SERVICE BULLETIN

N° 189-332

ATA 56 - WINDOW GASKET UPGRADE

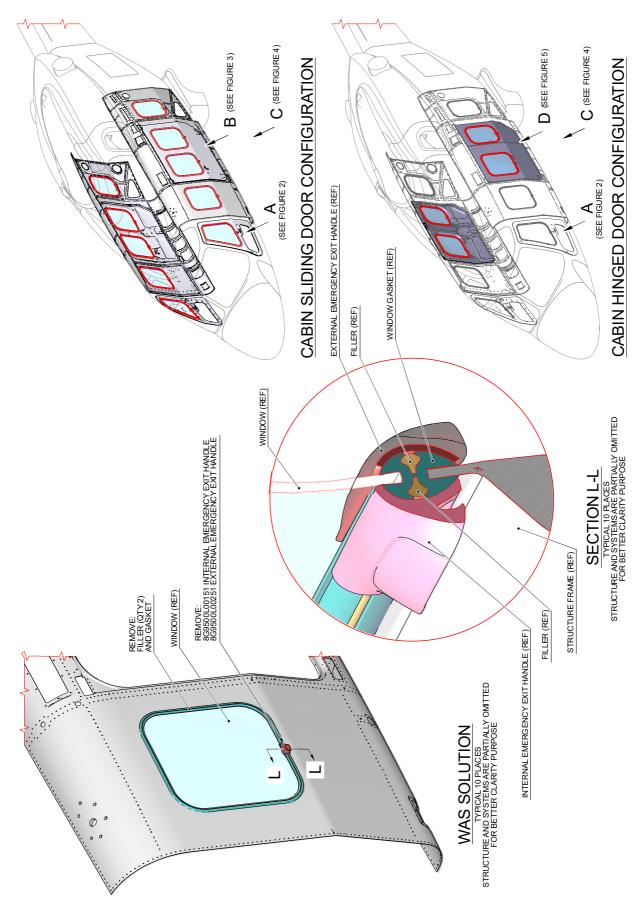
The gasket installation of the emergency exits is composed by a gasket bonded only to the transparent on both sides (internal and external) and a filler on each side (internal and external).

The improved design introduces a rubber retainer between the gasket and the structure which are respectively continuously bonded to the window and to the structure.

The new gasket installation leads the emergency exit jettison force independent from the bonding process between gasket and fuselage.

- 2.1 In accordance with the applicable steps of AMP DM 89-A-56-31-01-00A-920A-A and with reference to Figure 1 "Was Solution" and Section L-L, remove the internal and external emergency exit handles P/N 8G9500L00151 and P/N 8G9500L00251, the two fillers and the window gasket from the co-pilot door window.

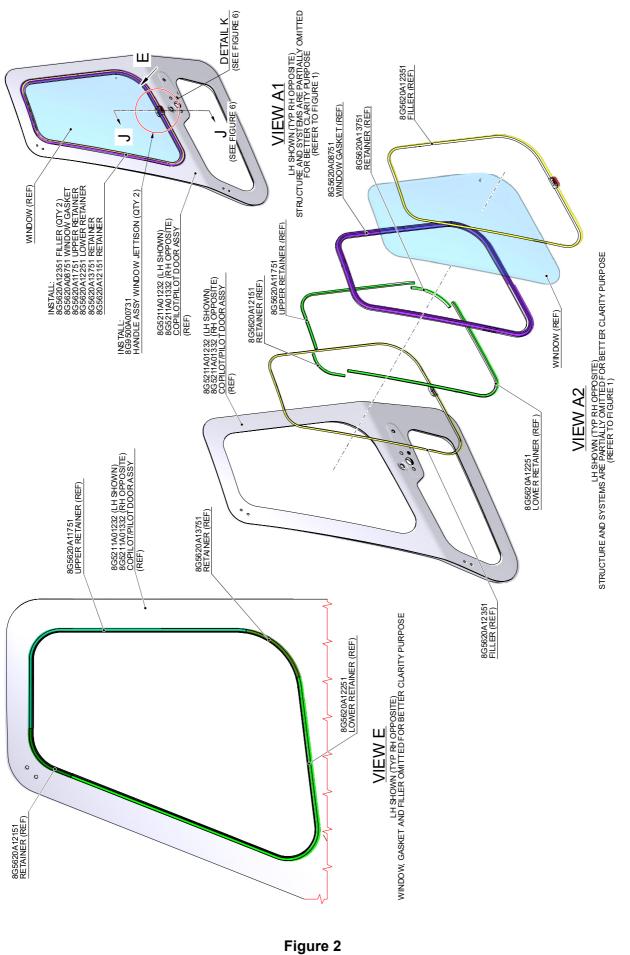
- 2.10 In accordance with the applicable steps of AMP DM 89-A-56-21-02-00A-920A-A repeat step 2.9 for the window on the RH side.
- 2.11 In accordance with the applicable steps of AMP DM 89-A-56-31-01-00A-920A-A and with reference to Figure 2 and Figure 6 Section J-J, bond the upper retainer P/N 8G5620A11751, the retainer P/N 8G5620A12151, the retainer P/N 8G5620A13751 and the lower retainer P/N 8G5620A12251 on the co-pilot door panel assy P/N 8G5211A01232 by means of adhesive RTV 732 (C126).

- 2.12 In accordance with the applicable steps of AMP DM 89-A-56-31-01-00A-920A-A and with reference to Figure 2 and Figure 6 Section J-J, install and bond the new window gasket P/N 8G5620A08751 to the co-pilot transparency P/N 4F5211A01351 and the retainers previously installed by means of adhesive RTV 732 (C126).

- 2.14 In accordance with the applicable steps of AMP DM 89-A-56-31-01-00A-920A-A and with reference to Figure 2 and Figure 6 Section J-J and Detail K, install the window jettison P/N 8G9500A00731 two handles assy (pull tab P/N 8G9500A03051 + clip P/N 8G9520A00251) in position on the two fillers P/N 8G5620A12351 then install the two fillers P/N 8G5620A12351 in the internal groove of the window gasket P/N 8G5620A08751 by means of adhesive RTV 732 (C126).

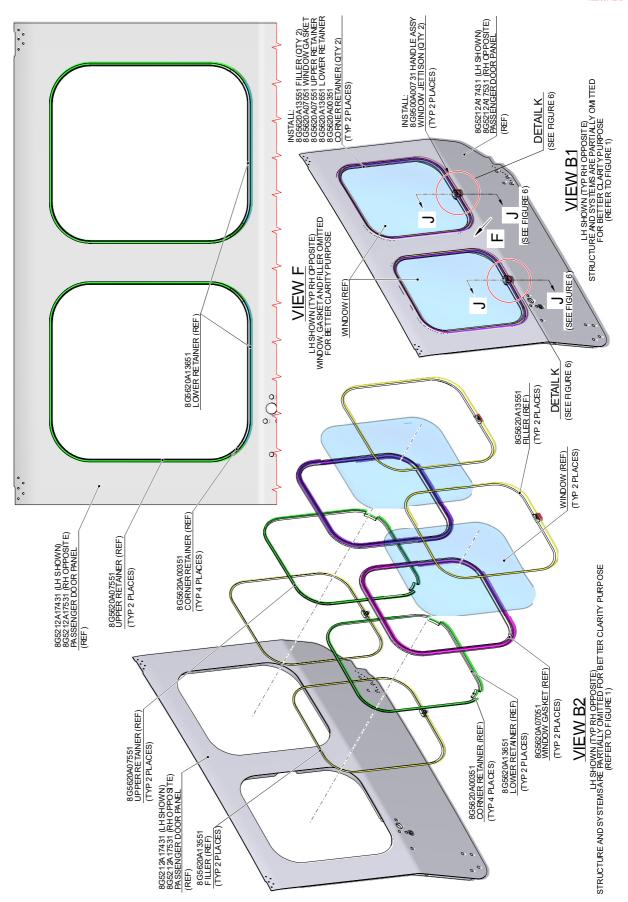
- 2.19 In accordance with the applicable steps of AMP DM 89-A-56-32-01-00A-920A-A and with reference to Figure 3 and Figure 6 Section J-J, bond n°2 upper retainers P/N 8G5620A07551, n°2 lower retainers P/N 8G5620A13651 and n°4 corner retainers P/N 8G5620A00351 on the passenger door panel P/N 8G5212A17431 by means of adhesive RTV 732 (C126).
- 2.20 In accordance with the applicable steps of AMP DM 89-A-56-32-01-00A-920A-A and with reference to Figure 3 and Figure 6 Section J-J, install and bond n°2 new window gaskets P/N 8G5620A07051 to the two LH FWD passenger door transparencies P/N 4F5630A00151 and P/N 4F5630A00351 and the retainers previously installed by means of adhesive RTV 732 (C126).

- 2.21 In accordance with the applicable steps of AMP DM 89-A-56-32-01-00A-920A-A and with reference to Figure 3 and Figure 6 Section J-J and Detail K, install the P/N four handles assy window jettison 8G9500A00731 (pull tab P/N 8G9500A03051 + clip P/N 8G9520A00251) in position on the four fillers P/N 8G5620A13551 then install the four fillers P/N 8G5620A13551 in the internal groove of the window gasket P/N 8G5620A07051 by means of adhesive RTV 732 (C126).
- 2.22 In accordance with the applicable steps of AMP DM 89-A-56-32-02-00A-920A-A, repeat steps from 2.19 to 2.21 for the RH FWD passenger door transparencies P/N 4F5630A00251 and P/N 4F5630A00451.

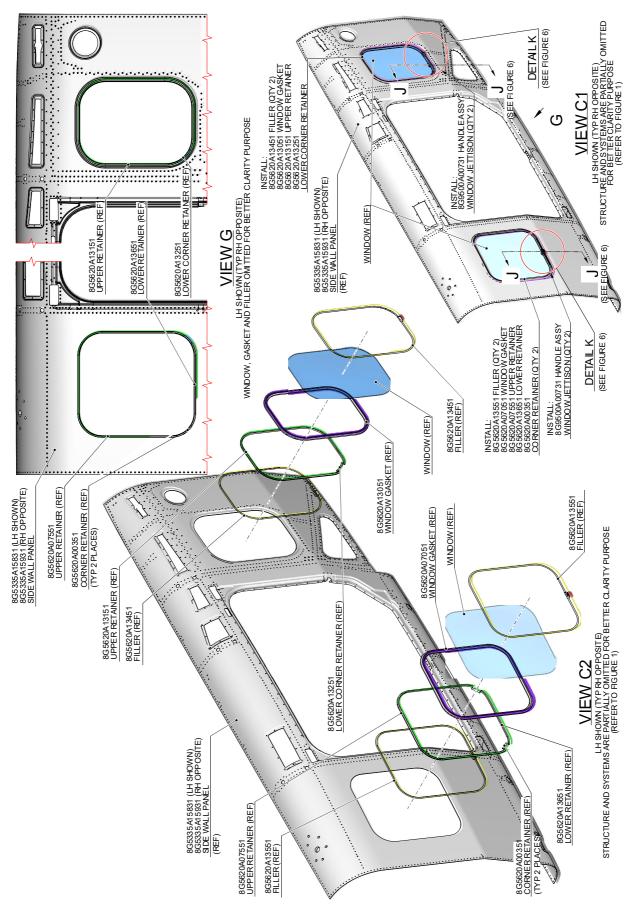
- 2.15 In accordance with the applicable steps of AMP DM 89-A-56-21-03-00A-920A-A and with reference to Figure 4 and Figure 6 Section J-J, bond the upper retainer P/N 8G5620A13151 and the lower corner retainer P/N 8G5620A13251 on the side wall panel P/N 8G5335A15831 by means of adhesive RTV 732 (C126).

- 2.16 In accordance with the applicable steps of AMP DM 89-A-56-21-03-00A-920A-A and with reference to Figure 4 and Figure 6 Section J-J, install and bond the new window gasket P/N 8G5620A13051 to the LH aft passenger cabin transparency P/N 8G5620A00451 and the retainers previously installed by means of adhesive RTV 732 (C126).

- 2.17 In accordance with the applicable steps of AMP DM 89-A-56-21-03-00A-920A-A and with reference to Figure 4 and Figure 6 Section J-J and Detail K, install the two handles assy window jettison P/N 8G9500A00731 (pull tab P/N 8G9500A03051 + clip P/N 8G9520A00251) in position on the two fillers P/N 8G5620A13451 then install the two fillers P/N 8G5620A13451 in the internal groove of the window gasket P/N 8G5620A13051 by means of adhesive RTV 732 (C126).
- 2.18 In accordance with the applicable steps of AMP DMs 89-A-56-31-02-00A-920A-A and 89-A-56-21-04-00A-920A-A, repeat steps from 2.11 to 2.17 for the pilot transparency P/N 4F5211A15851 and the RH aft passenger cabin transparency P/N 8G5620A00551.

2.30 In accordance with the applicable steps of AMP DM 89-A-56-21-01-00A-920A-A and with reference to Figure 4 and Figure 6 Section J-J, bond the upper retainer P/N 8G5620A07551, the lower retainer P/N 8G5620A13651 and n°2 corner retainers P/N 8G5620A00351 on the side wall panel P/N 8G5335A15831 by means of adhesive RTV 732 (C126).

2.31 In accordance with the applicable steps of AMP DM 89-A-56-21-01-00A-920A-A and with reference to Figure 4 and Figure 6 Section J-J, install and bond the new window gasket P/N 8G5620A07051 to the LH FWD passenger cabin transparency P/N 4F5630A00551 and the retainers previously installed by means of adhesive RTV 732 (C126).

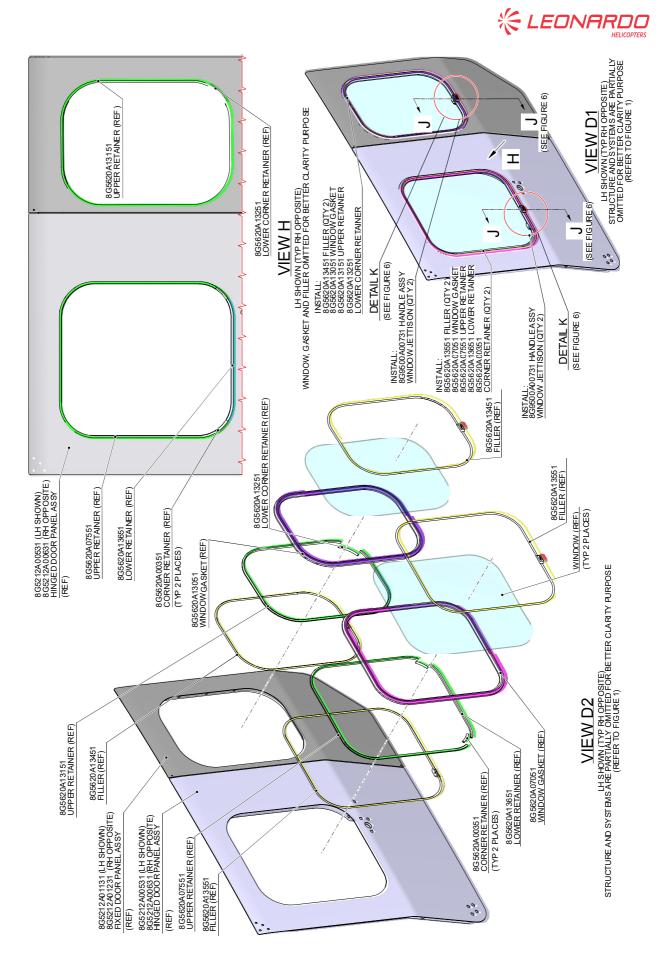
- 2.23 In accordance with the applicable steps of AMP DM 89-A-56-33-01-00A-920A-A and with reference to Figure 5 and Figure 6 Section J-J, bond the upper retainer P/N 8G5620A07551, the lower retainer P/N 8G5620A13651 and n°2 corner retainers P/N 8G5620A00351 on the hinged door panel P/N 8G5212A00531 by means of adhesive RTV 732 (C126).
- 2.24 In accordance with the applicable steps of AMP DM 89-A-56-33-01-00A-920A-A and with reference to Figure 5 and Figure 6 Section J-J, install and bond the new window gasket P/N 8G5620A07051 to the LH hinged door transparency P/N 4F5630A00151 and the retainers previously installed by means of adhesive RTV 732 (C126).

2.25 In accordance with the applicable steps of AMP DM 89-A-56-33-01-00A-920A-A and with reference to Figure 5 and Figure 6 Section J-J, install the two handles assy window jettison P/N 8G9500A00731 (pull tab P/N 8G9500A03051 + clip P/N 8G9520A00251) in position on the two fillers P/N 8G5620A13551 then install the two fillers P/N 8G5620A13551 in the internal groove of the window gasket

- 2.26 In accordance with the applicable steps of AMP DM 89-A-56-33-03-00A-920A-A and with reference to Figure 5 and Figure 6 Section J-J, bond the upper retainer P/N 8G5620A13151 and the lower corner retainer P/N 8G5620A13251 on the fixed door panel P/N 8G5212A01131 by means of adhesive RTV 732 (C126).
- 2.27 In accordance with the applicable steps of AMP DM 89-A-56-33-03-00A-920A-A and with reference to Figure 5 and Figure 6 Section J-J, install and bond the new window gasket P/N 8G5620A13051 to the LH fixed door transparency P/N 8G5620A00451 and the retainers previously installed by means of adhesive RTV 732 (C126).

- 2.28 In accordance with the applicable steps of AMP DM 89-A-56-33-03-00A-920A-A and with reference to Figure 5 and Figure 6 Section J-J, install the two handles assy window jettison P/N 8G9500A00731 (pull tab P/N 8G9500A03051 + clip P/N 8G9520A00251) in position on the two fillers P/N 8G5620A13451 then install the two fillers P/N 8G5620A13451 in the internal groove of the window gasket P/N 8G5620A13051 by means of adhesive RTV 732 (C126).
- 2.29 In accordance with the applicable steps of AMP DMs 89-A-56-33-02-00A-920A-A and 89-A-56-33-04-00A-920A-A, repeat steps from 2.23 to 2.28 for the right hinged door window P/N 4F5630A00251 and the right fixed cabin door window P/N 8G5620A00551.

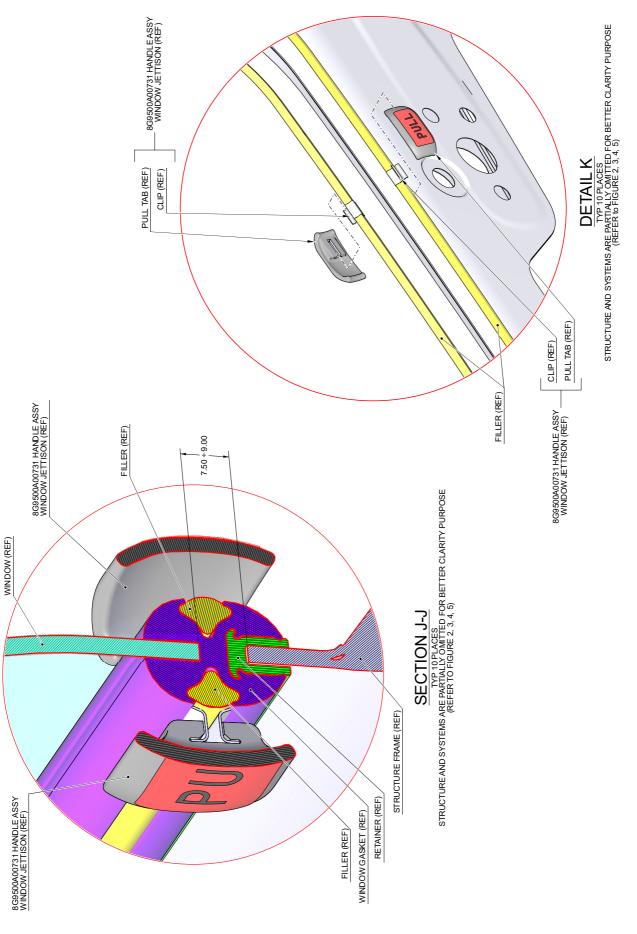
In addition, this Service Bulletin introduces new internal and external pull tabs which hold the filler and the handle.
